Submission to CEC re Sio Silica Sand Extraction proposal

This letter represents a written submission to the CEC in relation to the Sio Silica Sand Extraction Project (Public Registry 6119.00).

Fig 1. Within a well extraction site. The “angle of repose” of the sand is too shallow to allow for a “pillar” to develop between extraction sites. Assuming a well depth of 10m below the shale aquitard, the sand will leave a gap of 3 meters at its highest point.

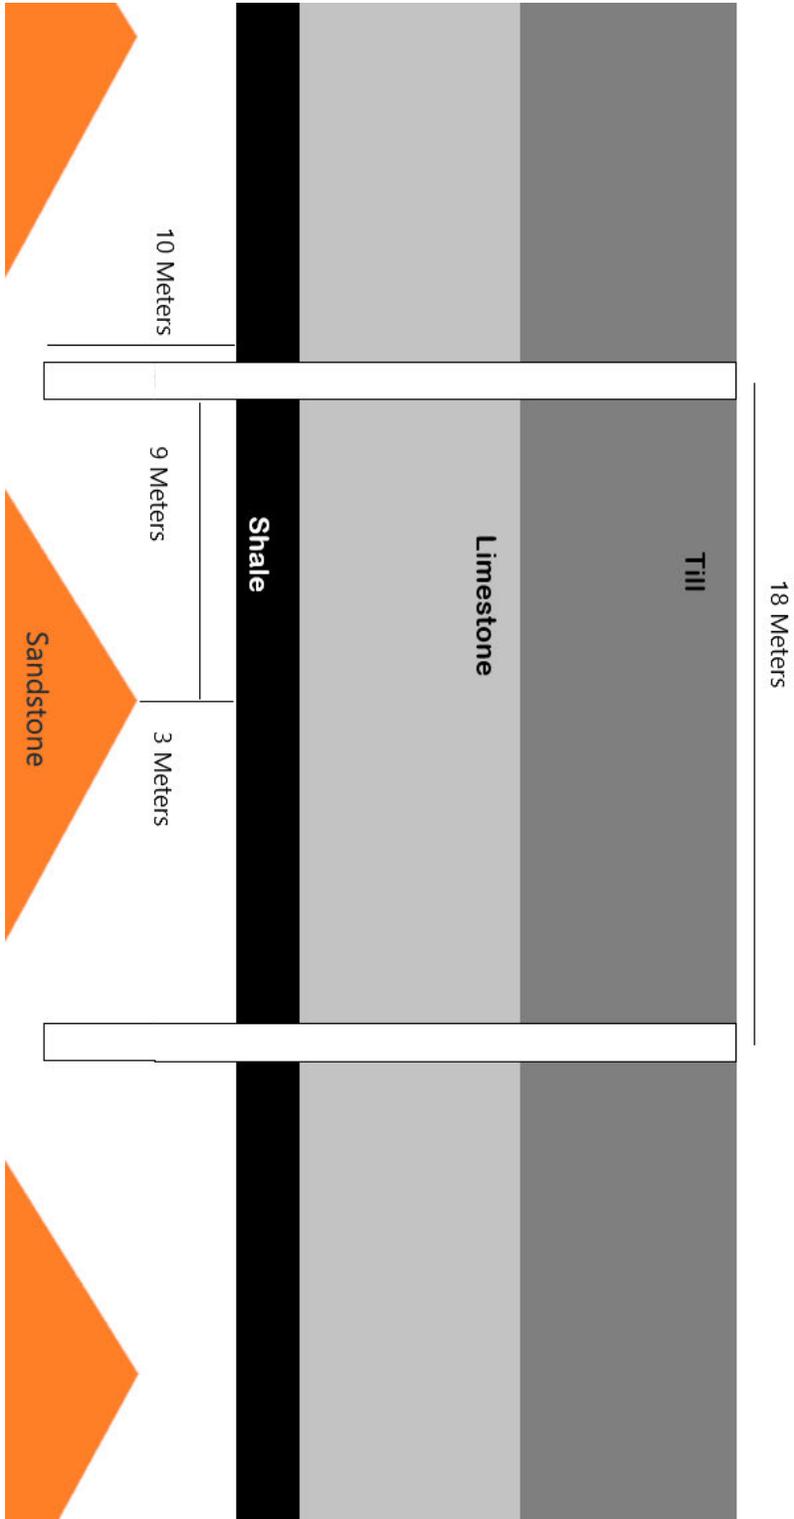
To use a room and pillar approach to a sand mine, where the sand itself is in an aquifer is an altogether different situation. In this case, the sand does not form a conventional “pillar”. Indeed, the sand will naturally slope down – and as calculated water filled sand will naturally form an “angle of repose” of about 15-30 degrees. [Hamzah M et al. 2018. *A review on the angle of repose of granular materials*. Powder Technology. 330. 397-417. 10.1016/j.powtec.2018.02.003.]. If the extraction sites are a long distance apart, it is possible that the sloped sand can still form some sort of “pillar”. However, the proposal is for extraction sites which are 18m apart. Under these conditions, the sand is unlikely to be able to form an adequate pillar (Fig 1). The results of not forming an adequate pillar are several and include -intermixing of the waters of the two aquifers and subsidence of the ground above the extraction site(s). The company is planning to operate up to 467 extraction wells annually.
